*Owner Occupied and Scattered Site Rehabilitation Programs*

**ADDENDUM ACKNOWLEDGEMENT**

**Addendum # 2  
January 7, 2016**

Project # 1068 Property Address: 8 Tremont Street, Milford, CT

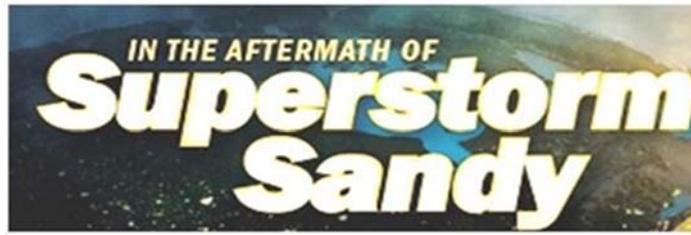
Helical Piles/ Load Test and Depth

To Whom It May Concern, In unit pricing it mentions a depth for the helical piles would be found on S-2, I can't seem to find it. Can someone give me the depth?

Who be performing the load test on the helical piles and who will be paying for it.

Per the geotechnical investigation report, included with the specifications as Section 00 31 32 Geotechnical Data, on page 130, paragraph 5.2 the helical piles are expected to achieve an ultimate compressive capacity of 20 Tons/pile within a depth of 50 feet. The unit pricing will be used for payment on installation of piles in depths exceeding 50 feet. In Section 31 66 15 – ‘Helical Piles’, paragraph 1.3 Submittals on page 492 of the specifications; the contractor is required to prepare a helical screw pile design, signed and sealed by a Professional Engineer in the State of Connecticut, at the contractors cost.

Regarding the load testing, please refer to specification Section 31 66 15 – ‘Helical Piles’, paragraph 3.2 Load Tests on page 496; one pile shall be load tested. The procedure(s) shall be proposed by the contractor and approved by the design engineer. The contractor is required to pay for the helical screw pile design and cost to test one helical pile on site.
